# **environmental statement**

## **OYSTER CREEK NUCLEAR GENERATING STATION**

DOCKET NO. 50-219

**DECEMBER 1974**

**FIGURE 11.1** OYSTER CREEK THERMAL FIELD  
(Based on Data of July 13, 1973)

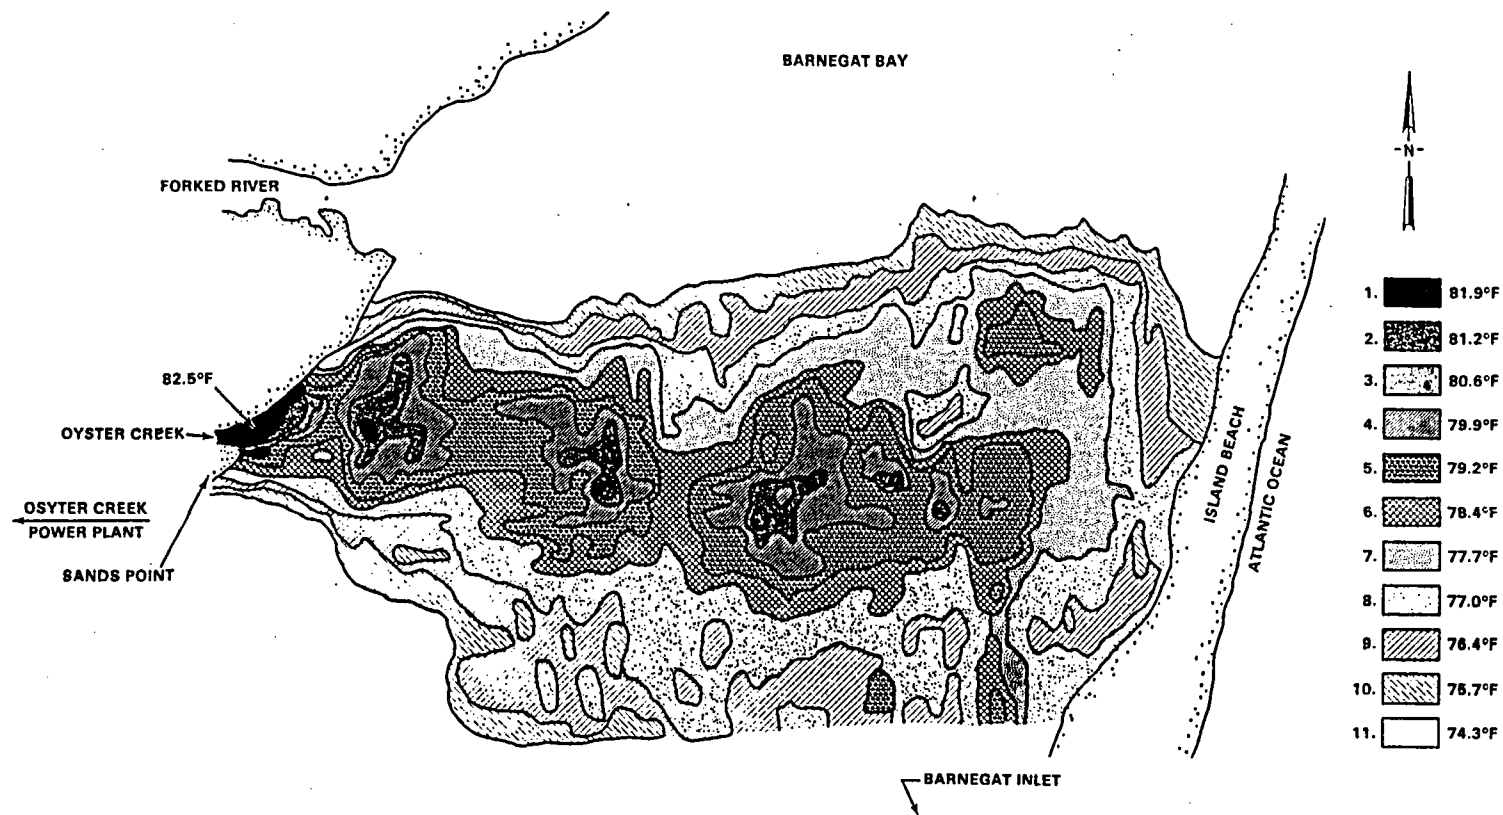
Response: Recent data show that the plant discharge produces a thermal field extending over the full width of the bay and imposing a temperature differential of more than 1.5°F over ambient water temperatures. The thermal plume on July 13, 1973, when the data were taken, extended from the mouth of Oyster Creek to Island Beach, as shown in Figure 11.1. The projection extended essentially eastward. Conceivably patterns proceeding northeasterly or southeasterly could occur, depending upon current direction, although there are no additional supporting data.

Response: See Fig. 11.1
